From: Helgardt Slabbert <helgardt@valumax.co.za>
Sent: Friday, September 11, 2020 2:39 PM
To: Vanessa Stippel
Cc: De Wet Botha
Subject: RE: 21637 | Notification of Public Review of EIA Report and WULA Technical Report | Proposed Development of Riverside View Extension 84, City of Johannesburg, Gauteng (GAUT 002/17-18/E2040)

ADDENDUM 1 | RESPONSE TO CITY OF JOHANNESBURG IMPACT ASSESSMENT AND COMPLIANCE MONITORING COMMENTS DATED 12 OCTOBER 2020

ADDENDUM 2 | RESPONSE TO GDARD'S COMMENTS DATED 26 OCTOBER 2020

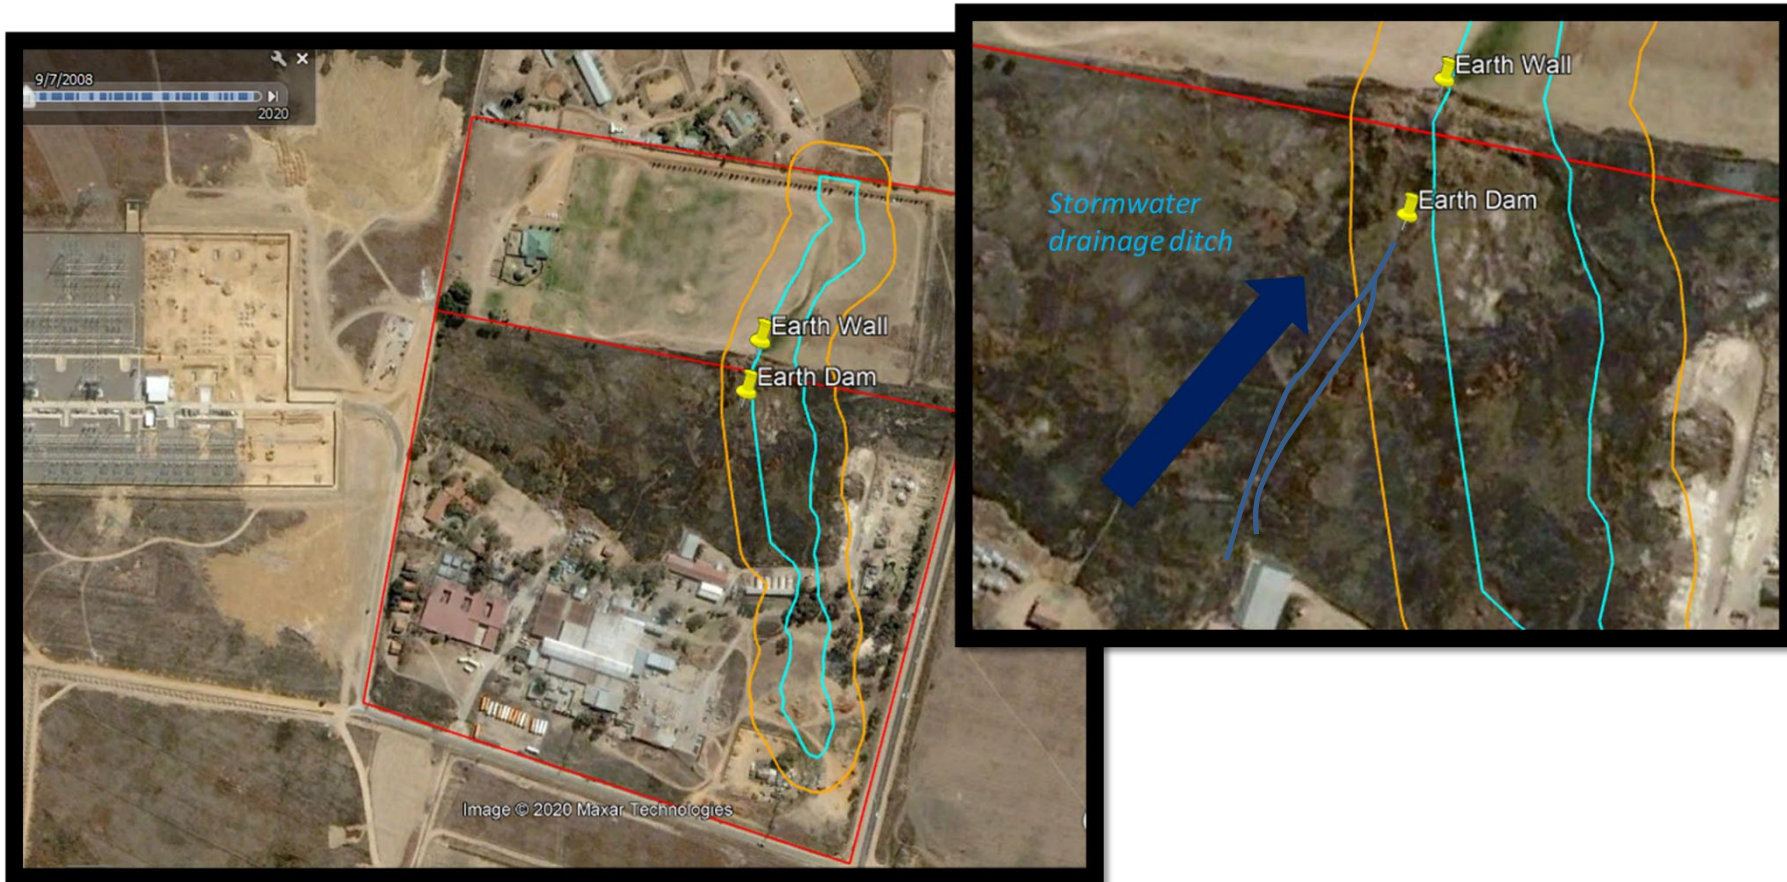
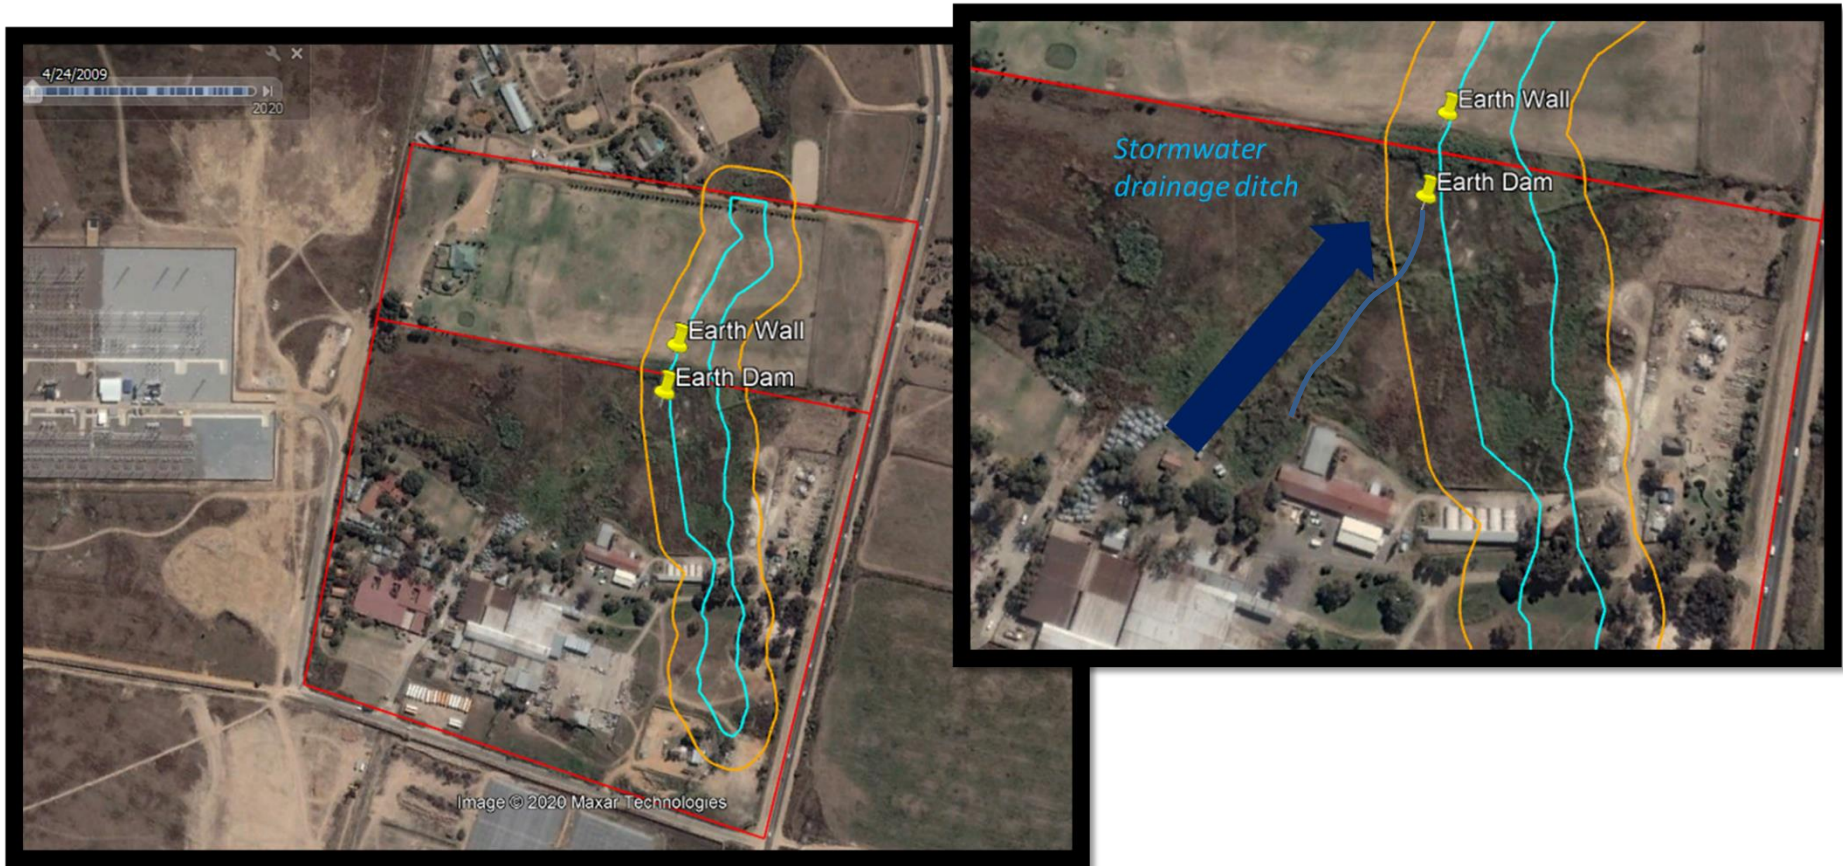
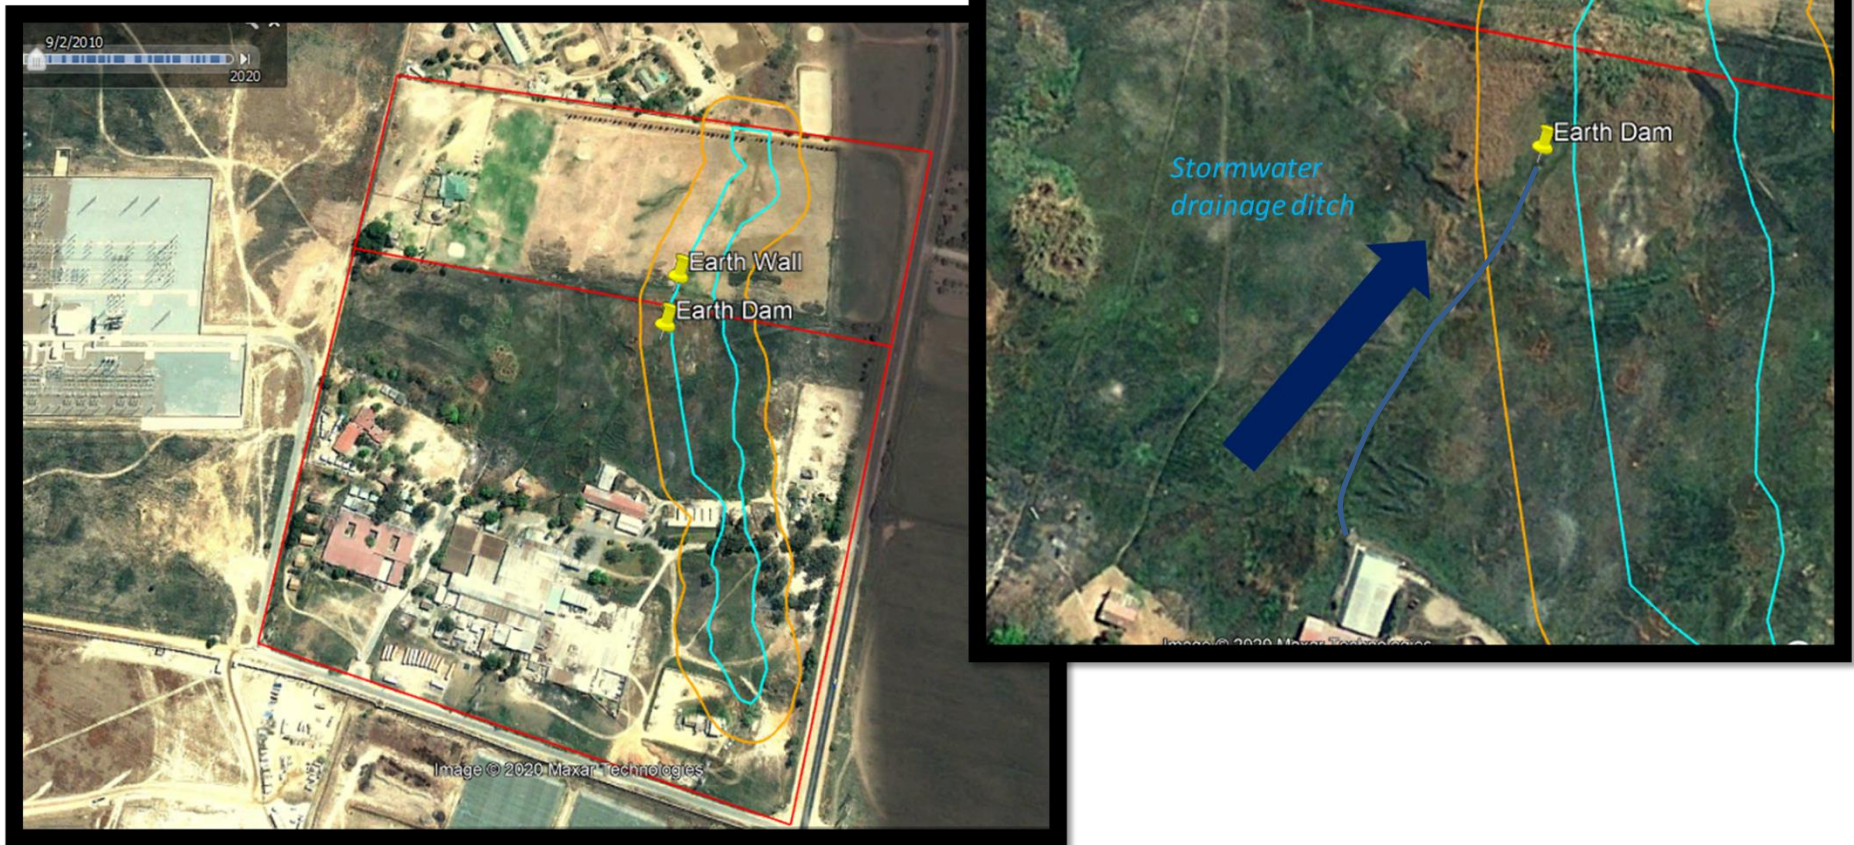
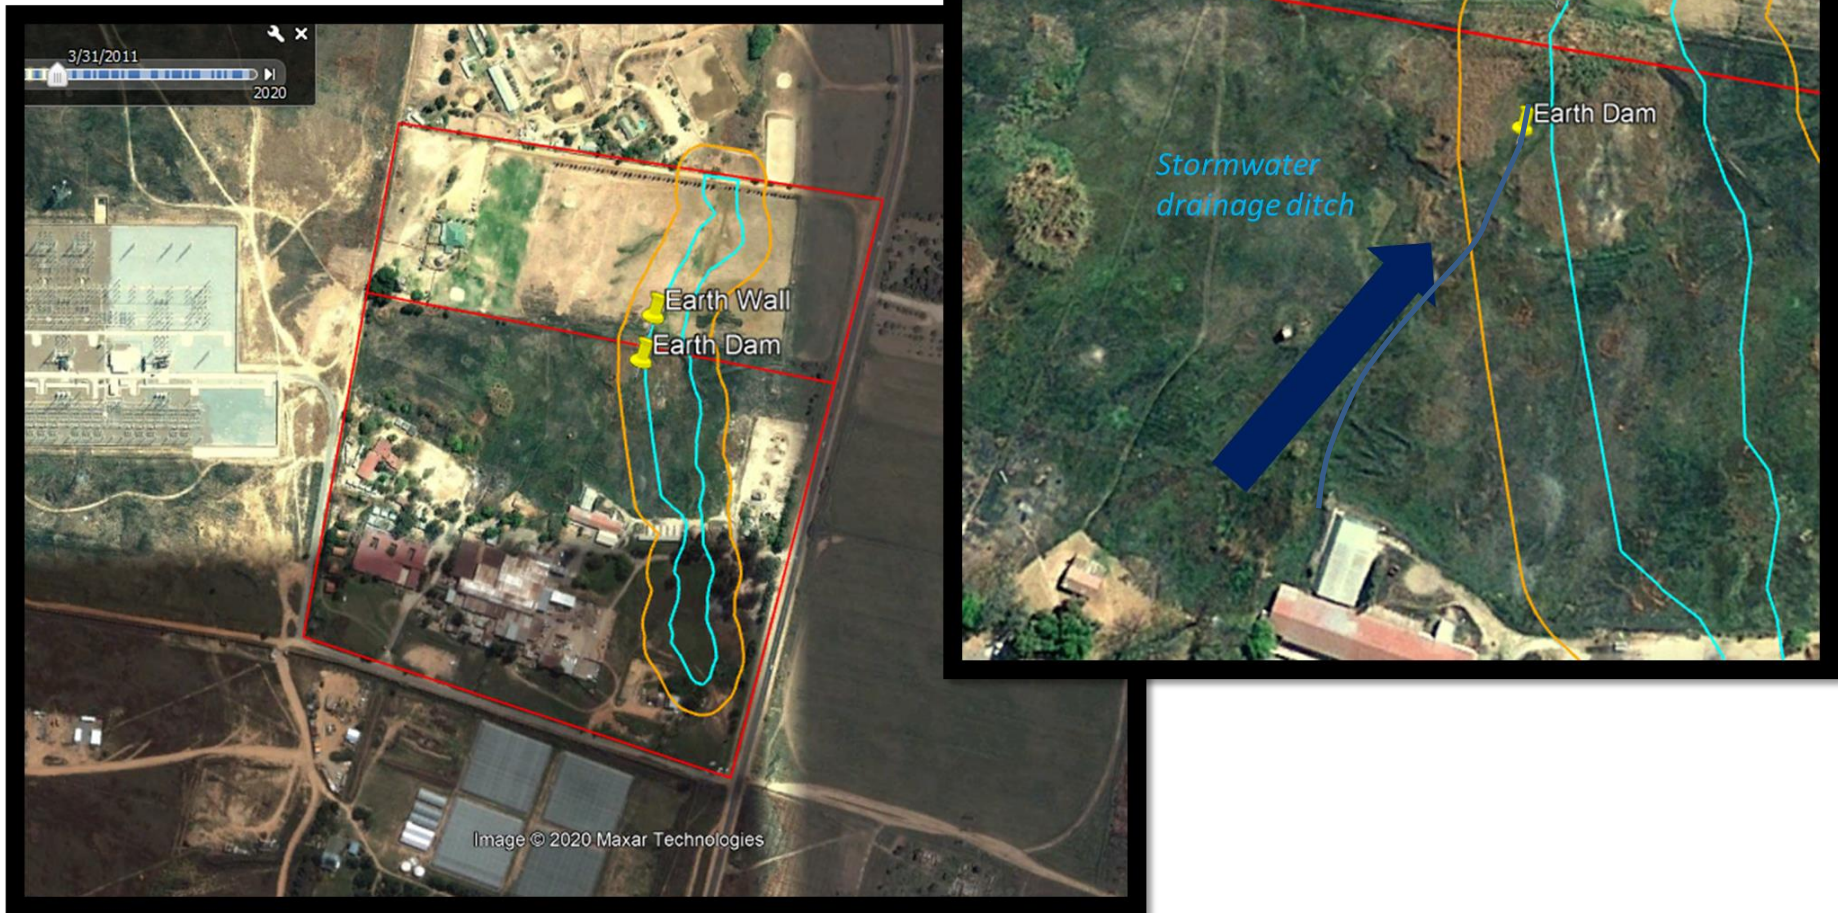
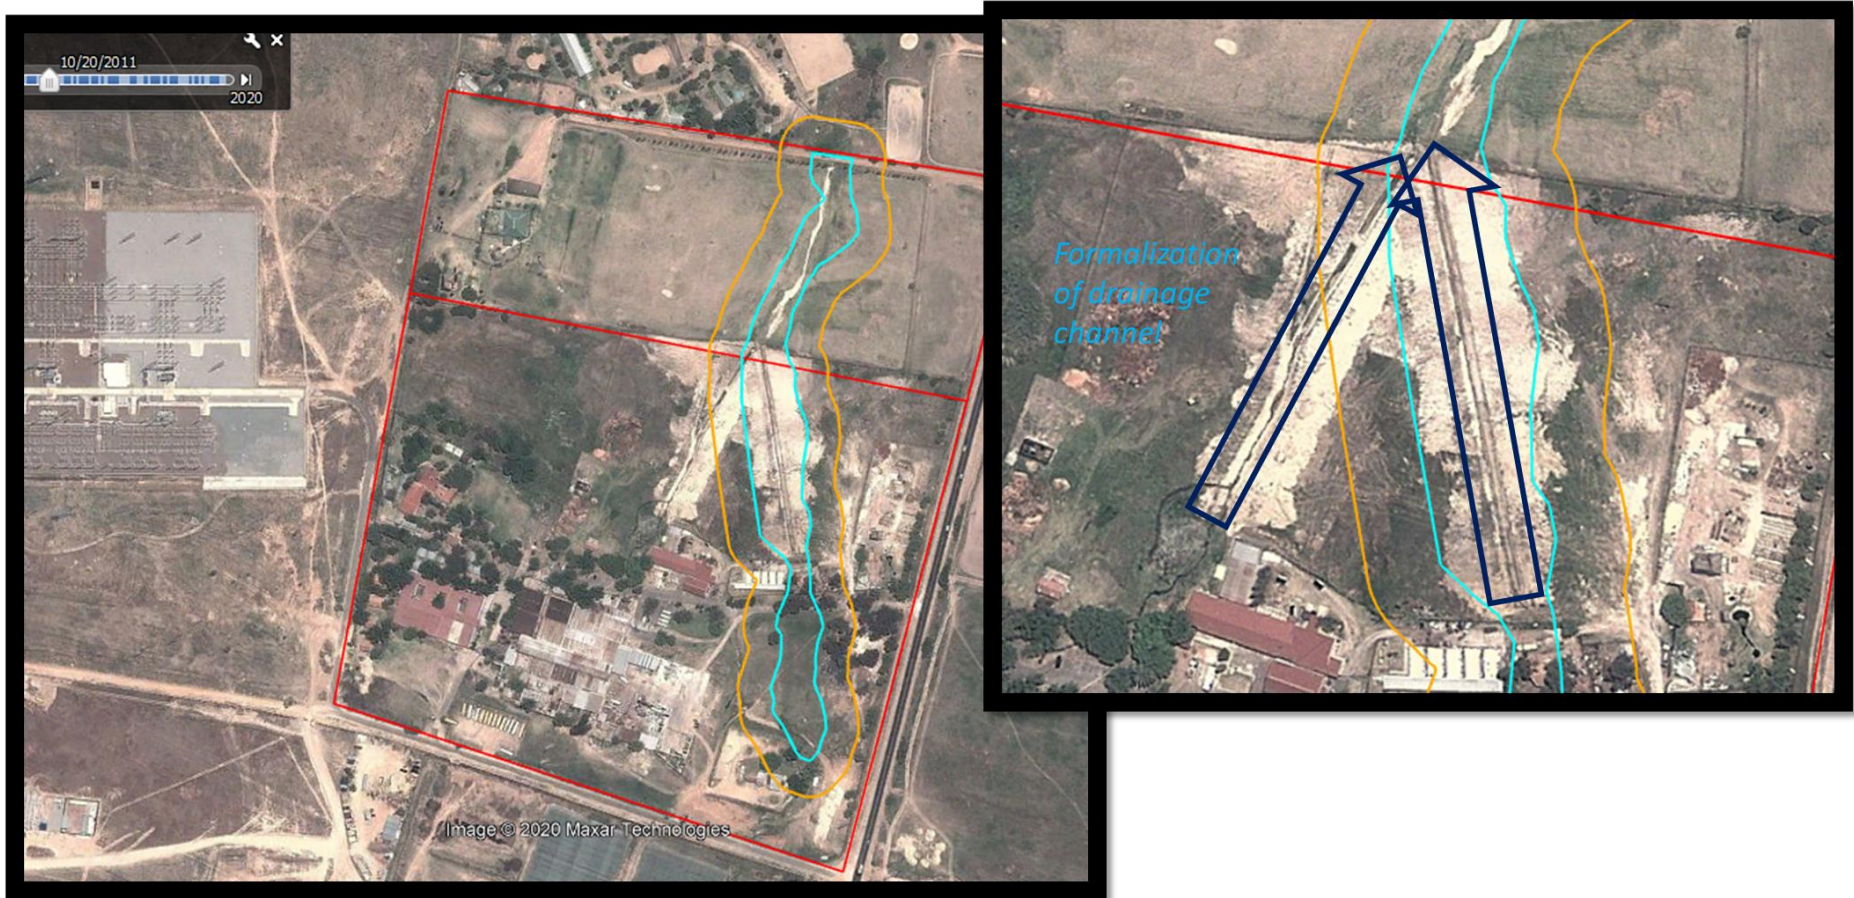
- Page 41 on wetland report indicated as figure 6.4 it display the wetland on site as per the Departmental Information System (GIS) but when its delineated on page 45 as figure 6.8 the other part which is on Erf 1 it's no longer delineated as wetland a clarity must be provided because even on site visit even the reeds were observed on that part.

Google Earth imagery has therefore been utilized to provide a summary of the historic use of the site and how this has affected surface water. The aim of this is to provide a timeline and to explain the current status of the site.

Please refer to **Figure 2, 3 and 4** below.

*“The general slope of the area is to the north with locally gradients towards the east and west due to a shallow stream channel running from south to north through the eastern part of the holding. **The drainage feature has been modified due to stormwater trenches, runoff from large concrete paved areas and septic tank drainage fields. A stormwater drainage ditch runs through the central part of the holding into an earth dam on the central northern boundary with the golf driving range. The shallow stream and dam areas will be prone to marshy conditions. Locally levelled platforms were created via cut to fill to accommodate the large paved areas and buildings.**”*

*The northern parts of the site have been left fairly undisturbed apart from the **shallow dam in this area**. The school on the western part comprises of classrooms, sports fields and open veldt area to the north. The Lulamisa Eskom Substation is situated directly adjacent to the west of the property.”*
